# SERVICE BULLETIN

No. 301A

Piper Aircraft Corporation

- Subject: Reissued Airplane Flight Manual and New Placards  
(Reference FAA Airworthiness Directive for PA-30 dated November 5, 1969)
- Models Affected: PA-30 Twin Comanche

Serial numbers 30-1 to 30-1716 inclusive, 30-1718 to 30-1744 inclusive

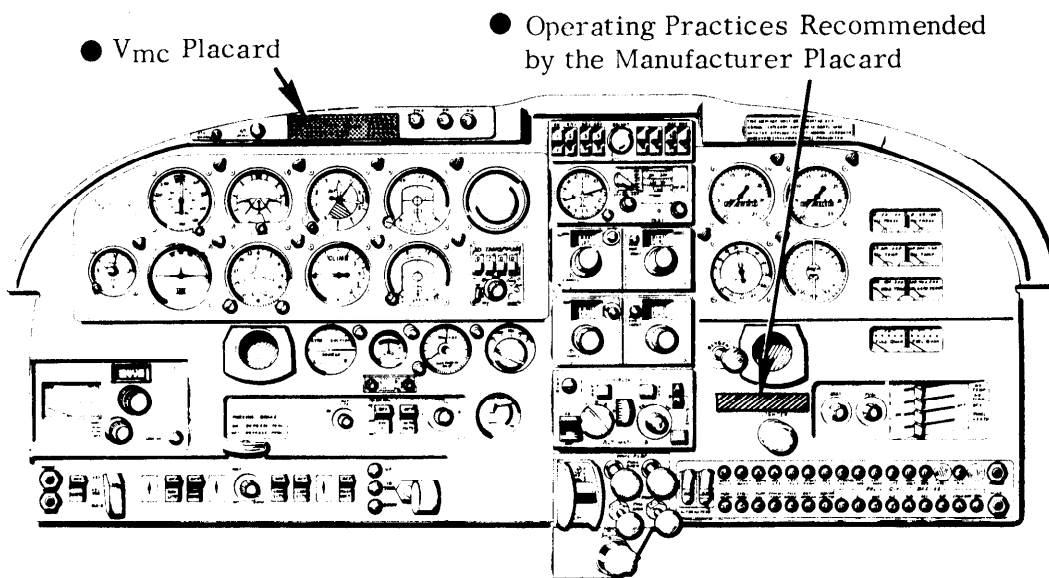
- Instructions:
- I. Aircraft serial numbers 30-1 to 30-1716, 30-1718 to 30-1744 incl.:
    - A. Remove or cover existing minimum single engine control speed placard and install new Vmc placard, per sketch A, page 3 of this bulletin.

- B. Install new operating practices recommended by the manufacturer placard, located as denoted on Sketch A, page 3 of this bulletin.
    - C. Replace existing Section 1, Airplane Flight Manual Report No. 1269 with reissued Section 1 (reissue date 11/15/69), Airplane Flight Manual Report No. 1269, supplied with Vmc Placard Installation Kit part number 760 354 (reference Material Required, below).

- A. Remove or cover existing minimum single engine control speed placard; install new Vmc placard per Sketch B, page 3 of this bulletin.
  - B. Install new operating practices recommended by the manufacturer placard, located as denoted on Sketch B, page 3 of this bulletin.
  - C. Replace existing Section 1, Airplane Flight Manual Report No. 1515 with reissued Section 1 (reissue date 11/15/69), Airplane Flight Manual Report No. 1515, supplied with Vmc Placard Installation Kit part number 760 355 (reference Material Required, below).
- III. Page 7a (revised 6/30/69) of Weight and Balance Section of Airplane Flight Manual Report Nos. 1269 and 1515, previously supplied with Service Bulletin No. 301, dated August 29, 1969 is not to be discarded, but must remain with the Airplane Flight Manual.
